CAVENDISH ER BRF 0146 (13)

CONTRACTOR FABRICATED PBU UNITS

T.Y. LIN INTERNATIONAL
 THE STAMPED DOCUMENTS ARE HEREBY:

Vermont Agency of Transportation

COLD RIVER BRIDGES, LLC 10 LANBRO LANE TEL 603-756-9300 WALPOLE, NH FAX 603-756-9303	
CAVENDISH ER BRF 0146(13)	
COVER SHEET/INDEX	SHEET NUMBER COVER
DATE: 2-17-14	Scale:

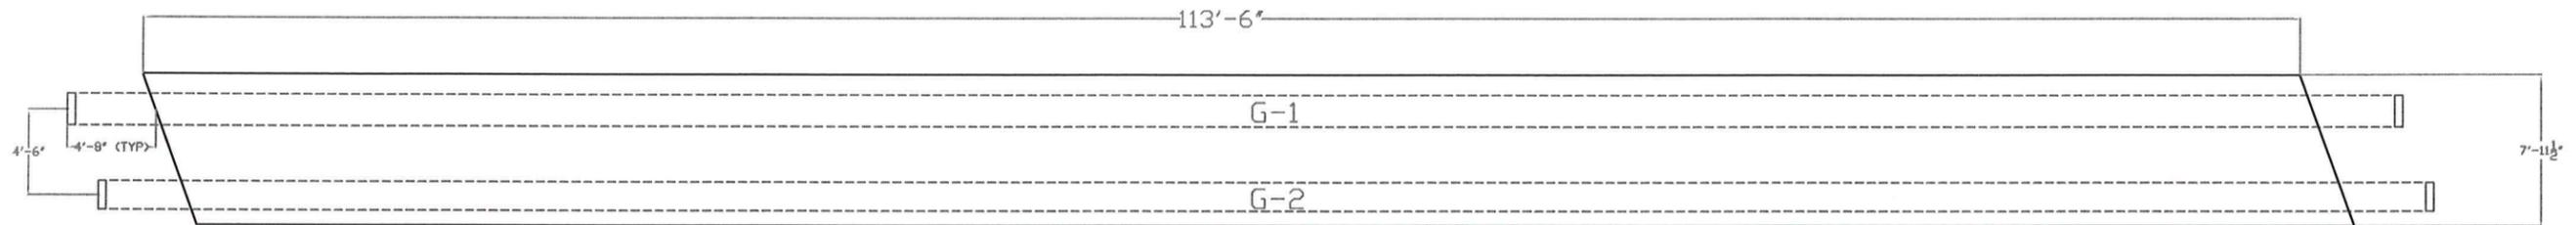
It should be understood that the Erection plan needs to be submitted and accepted before the structural steel gets to the site.
